TECHNICAL SERVICE BULLETIN

TSB-C-GN-SP-0029

Subject: Missing Teflon O-Ring Seals in TXV Kits for Residential Unitary Split Systems

Production Date on Kit Label

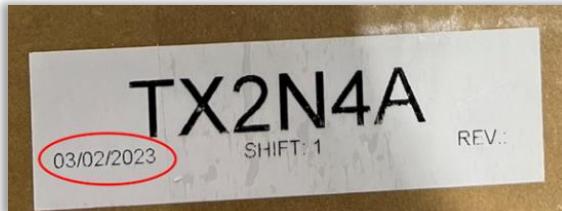
Limited TX*N2 and TX*N4 TXV kits were packaged without the Teflon O-ring seals. **Kits containing Danfoss TXV valves were shipped without the proper O-ring seals** between 11/01/2022 and 03/09/2023. See example below of production date listed on kit label.

Valve kits with date codes between 11/01/2022 and 03/09/2023 need to be inspected to ensure O-rings are included. Failure to use or replace the O-rings during installation of the valve may result in a refrigerant leak.

Please inspect all kits and if they are missing the O-ring seals, contact your CSR and reference this Technical Service Bulletin (TSB C-GN-SP-0029) to order part #B1796633. The O-ring seals are shipped in a bulk pack of 10 seals and will be sent at no charge.
